Concept for revised geophone cabling -v2

PI-Flange Signal Cable Detail

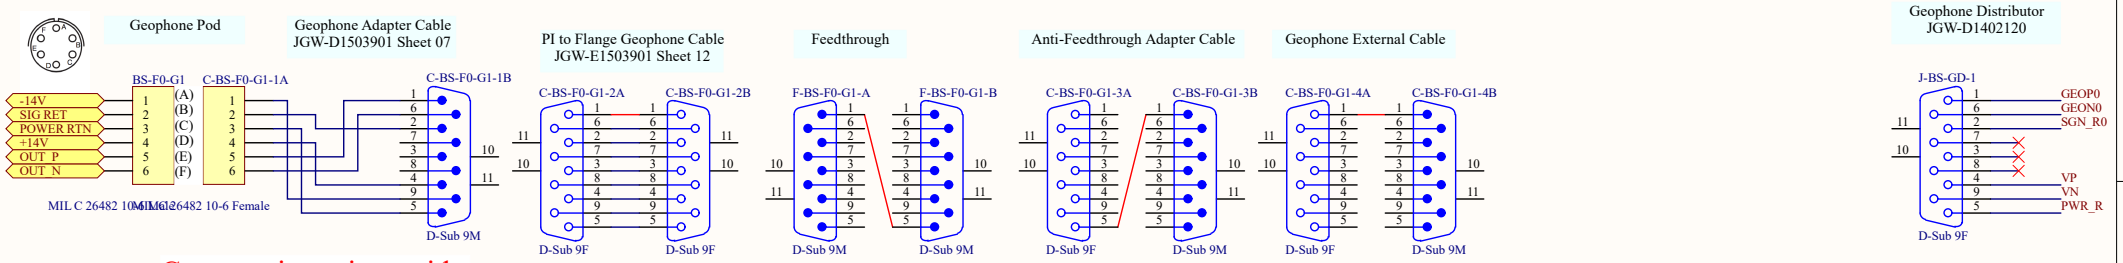
Current pinout is stupid, but matches geophone distributor.

Requires custom cable with conductor on Pin 9 - hard to make.

Better pinout

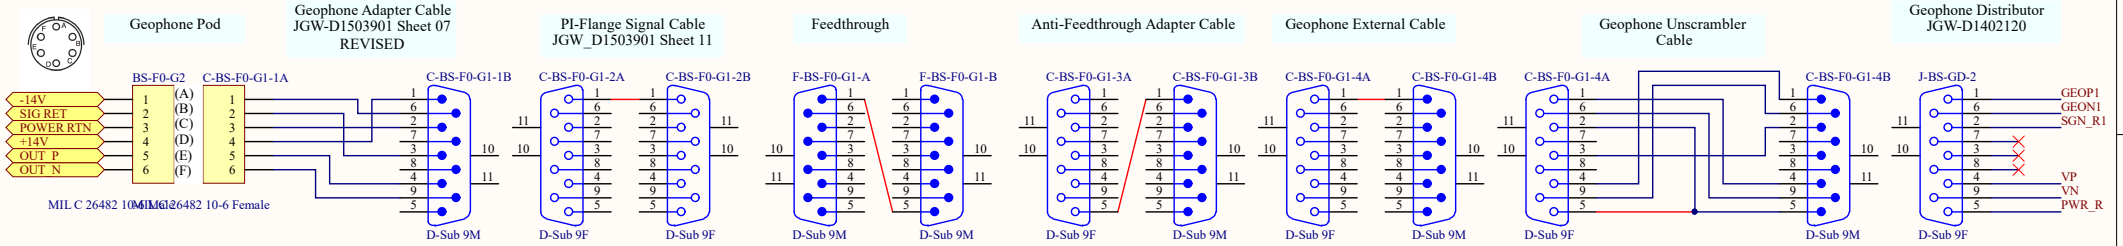
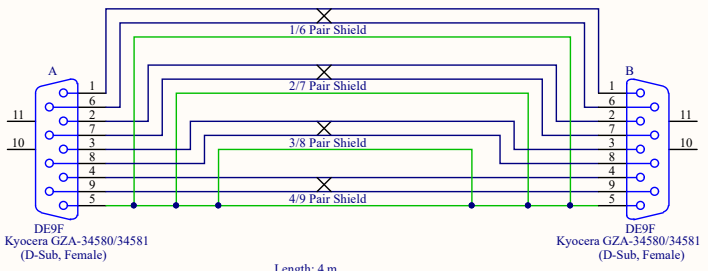
Use standard Type 1 cable ...

... plus unscrambler cable.

-v2 note: Aso-san suggests adding grounding connection in red, but this makes it equivalent to original (in that the shields on all the in-vacuum cables will be at PWR_R potential)! Maybe the original isn't so stupid after all.
